# MCO Applicant's Response to Relevant Representations

The East Midlands Gateway Phase 2  
and Highway Order 202X and The East Midlands Gateway  
Rail Freight and Highway (Amendment) Order 202X

# **The East Midlands Gateway Rail Freight and Highway (Amendment) Order 202X**

**(DOCUMENT MCO 7.2)**

Figure 1

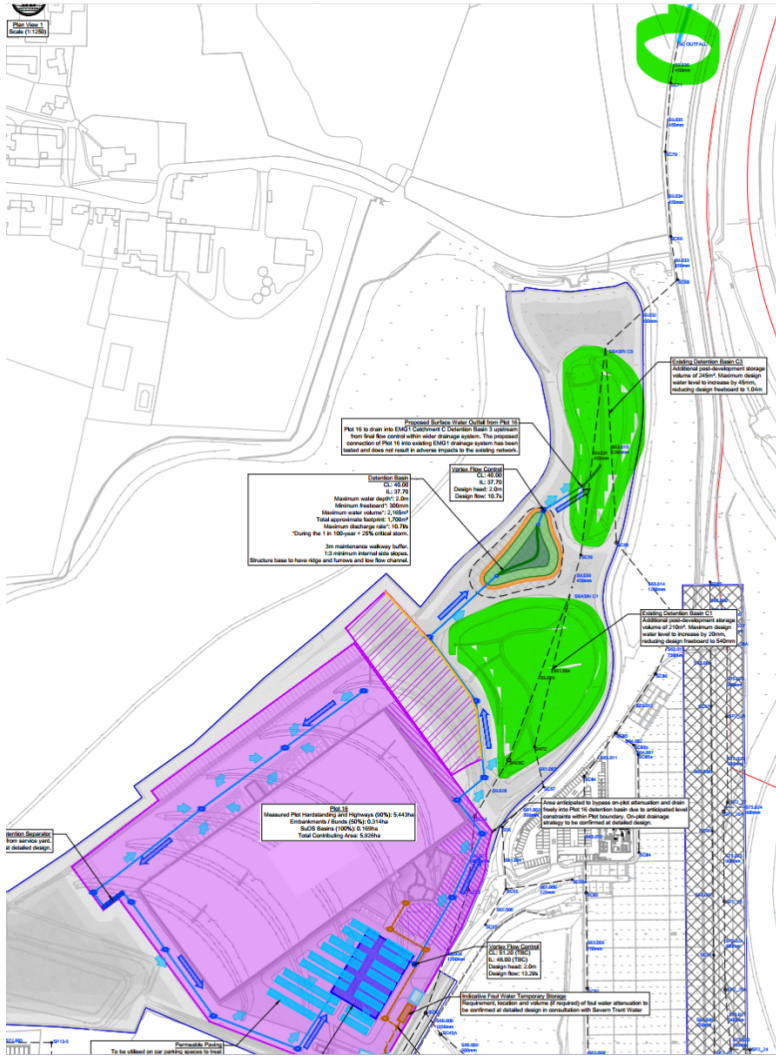
9.1.		<b><u>Groundwater and Contaminated Land</u></b>	
9.1.1.		<p><b>Document Reference(s):</b> APP-073 DCO 6.3 ES Chapter 3 Project Description – Sections 3.2.32 &amp; 3.2.41</p> <p>APP-141 6.13 ES Chapter 13 Flood Risk and Drainage – Section 13.6.61</p> <p>APP-147 DCO 6.13F ES Appendix F Water Framework Directive WFD Screening – Sections 2.31 &amp; 2.40</p> <p>APP-015M MCO 3.1 dMCO</p> <p><b>Issue</b> Contradictory or misleading information about potential requirement for piled foundations for buildings in Chapter 13. Potentially incorrect information given in Chapter 3 if so. Recommended requirement not included in draft MCO.</p> <p><b>Impact</b> Potential harm to receptors if requirement for Foundation Works Risk Assessment may be missed.</p> <p><b>Solution</b> Update Chapter 3 and all other relevant documents to include potential for piled foundations for buildings if this is the case. Update draft MCO with requirement as outlined in APP-147.</p> <p><b>Additional narrative/ explanation</b></p>	The WFD screening (APP-147) and ES Chapter 13 (APP-141) included a catchall statement regarding the foundation design and the potential trigger for a FWRA.

Response No.	Name of person making representation	Content of representation	MCO Applicant's Response
		<p>Chapter 3 states piled foundations are not proposed for buildings (3.3.12). In 13.6.61 it states: "Detailed foundation design has not been undertaken at this stage". This section does not specify if it relates to specific works, so the implication is that buildings may require piled foundations. It goes on to say: "if deeper piled foundations are required then, if not already completed, a Foundation Works Risk Assessment (FWRA) will be undertaken". We agree with this approach. A similar phrasing is used in the WFD screening. See APP-147 Sections 2.31, and Section 2.40 where it states: "This is expected to be secured as a requirement in the DCO."</p>

Figure 2

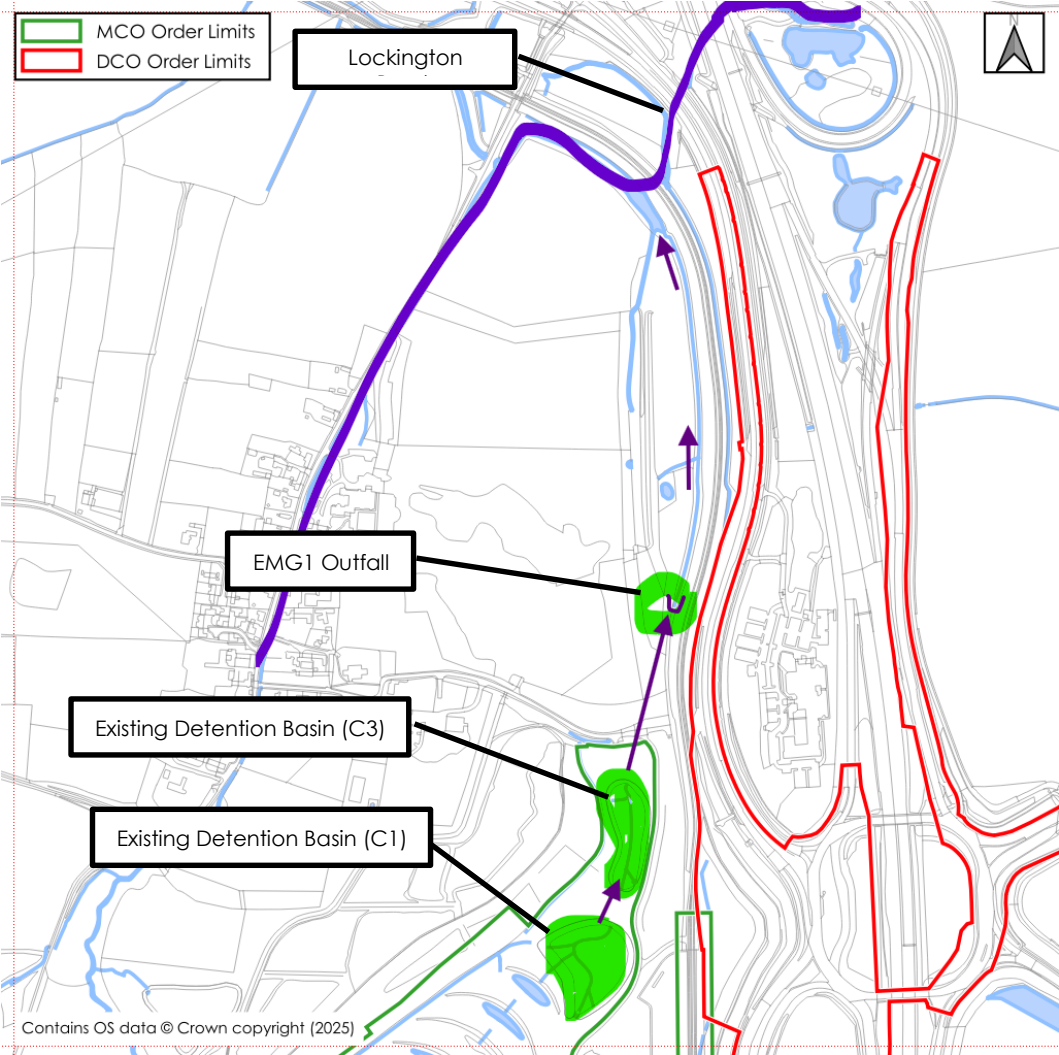
9.1.3.		<p><b>Document Reference(s):</b> APP-152 DCO 6.14 ES Chapter 14 Ground Conditions – Section 14.5.7</p> <p><b>Issue</b> Assessment of PFAS risk is limited and based on speculation. Based on the information presented, there is a potentially active migration pathway for PFAS in groundwater and surface to reach the MCO site.</p> <p><b>Impact</b> Potential for PFAS contamination within groundwater underlying the DCO site cannot be ruled out. This could pose a risk to future site users and the environment.</p> <p><b>Solution</b> CEMP to include testing for PFAS in any groundwater encountered during the construction phase. Include testing for PFAS in groundwater if any further intrusive ground investigation works are required.</p> <p><b>Additional narrative/ explanation</b></p> <p>The applicant speculates where a fire training area might be but has not clearly identified this. Based on the information presented, any PFAS contamination entering groundwater from the suspected fire training area would flow north, directly toward the MCO site.</p>	The EMG1 Works were authorised through the East Midlands Gateway Rail Freight Interchange Development Consent Order (EMG1 DCO), which was supported by a full Environmental Impact Assessment and Environmental Statement, including assessment of ground conditions and contamination risks. A review of the approved ground conditions ES Chapter documentation does not identify PFAS as a potential off-site source of contamination, nor any PFAS-specific monitoring or remediation requirements associated with that consent. The Applicant does not believe any monitoring provision is necessary.

Response No.	Name of person making representation	Content of representation	MCO Applicant's Response
		<p>Furthermore, while the fire training area might have the "highest potential for PFAS impact" it does not mean that other areas of the airport site have some potential for PFAS impact. Fire-fighting foam may have been used in many locations on the site. PFAS testing and monitoring data undertaken at the East Midlands Airport is not currently available to the applicant, so they cannot use this as an assessment of the potential for PFAS to impact the wider area.</p> <p><b>Document Reference(s):</b> APP-152 DCO 6.14 ES Chapter 14 Ground Conditions – Section 14.6.41</p> <p><b>Issue</b> Potential need for shallow dewatering does not have sufficient information. Temporary construction dewatering, and permanent dewatering may require a permit; this is not stated.</p> <p><b>Impact</b> Dewatering without appropriate permits or exemptions secured is an offence.</p> <p><b>Solution</b> Update the report and any associated discussion of dewatering elsewhere to include relevant information.</p> <p><b>Additional narrative/ explanation</b></p> <p>Shallow groundwater should be tested for PFAS and other contaminants of potential concern prior to release into the environment.</p>
